工程指示 / 要求簡箋(E.I.)

工程指示編號：EI / 7481 / 24

工程名稱：將軍澳日出康城 LP 11

工程項目：後加百葉 加工圖 (第三批) 大貨放行 (只暫停 11/F C1, 40/F C2)

TITLE :  
 IN-SITU ALUM. LOUVER LAYOUT PLAN  
 TOWER 1 - 11/F

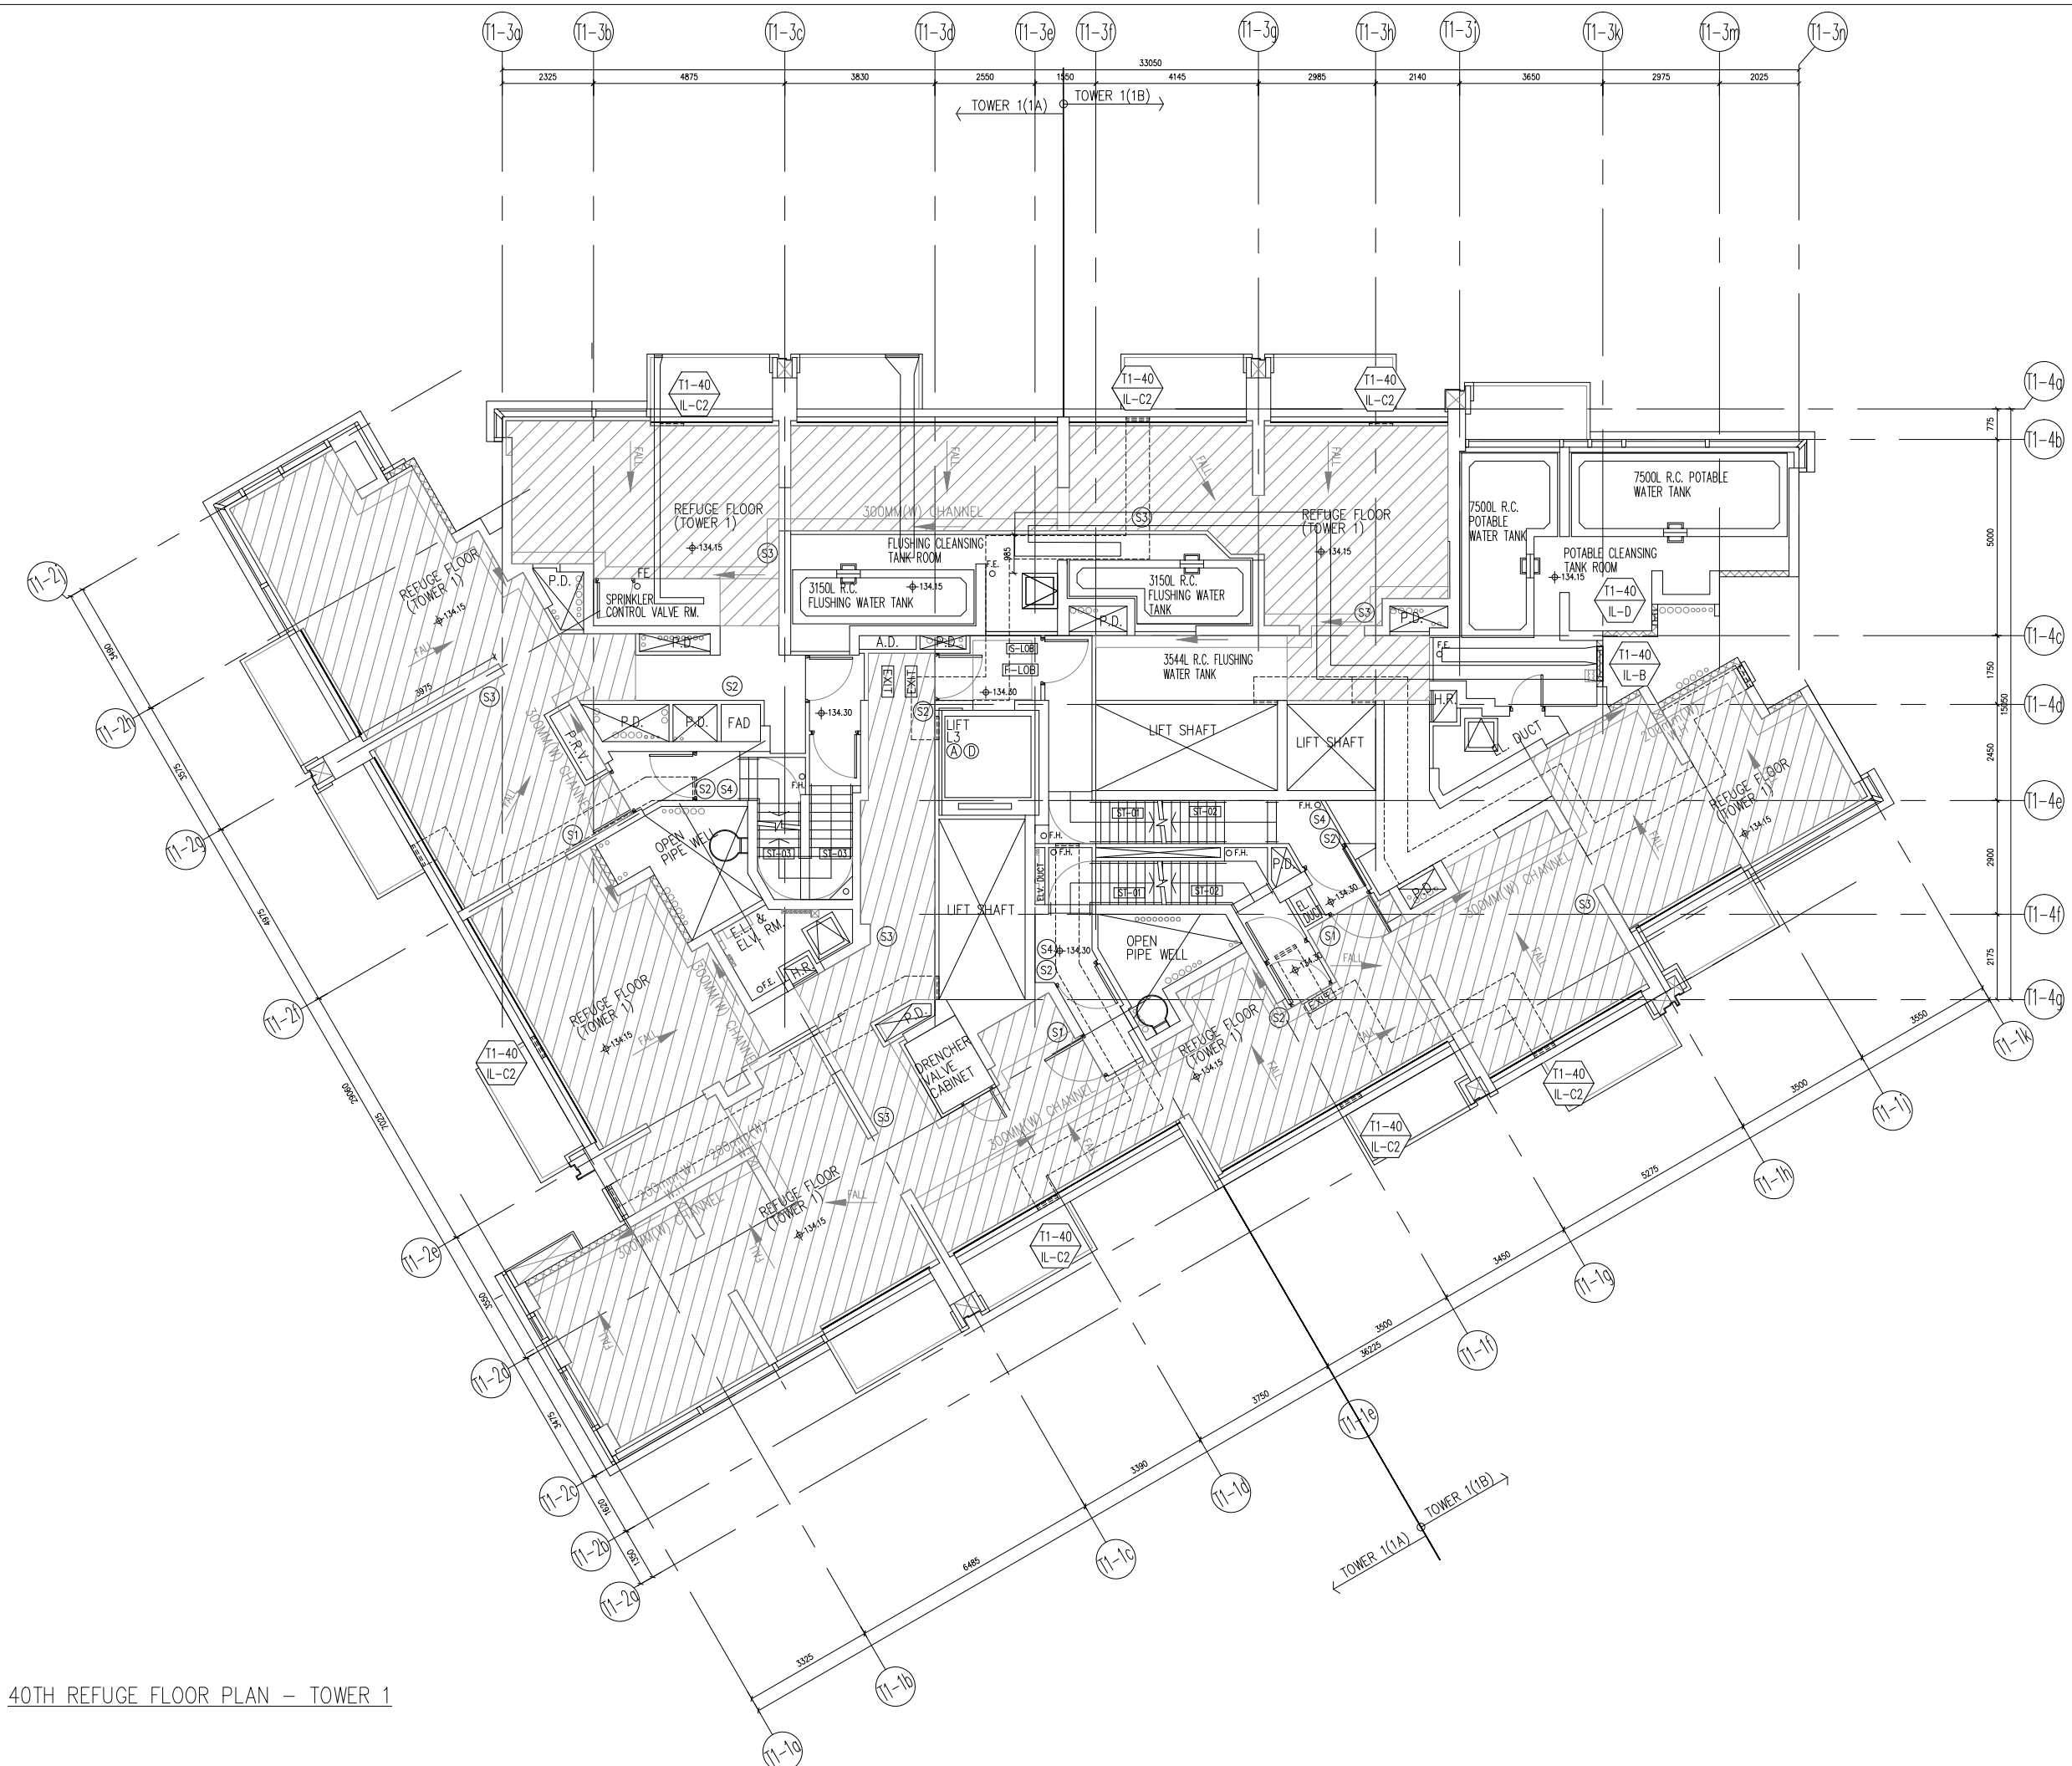
1. 因各座的 11/F C1 百葉, 40/F C2 百葉覆尺未有孔，暫停

→ (只暫停 11/F C1, 40/F C2) 全是 600Wx250H 共 36 隻暫停。 為免浪費鋁料，此 36 隻不開料

6. 地盆：請覆核各座的 11/F C1 百葉, 40/F C2
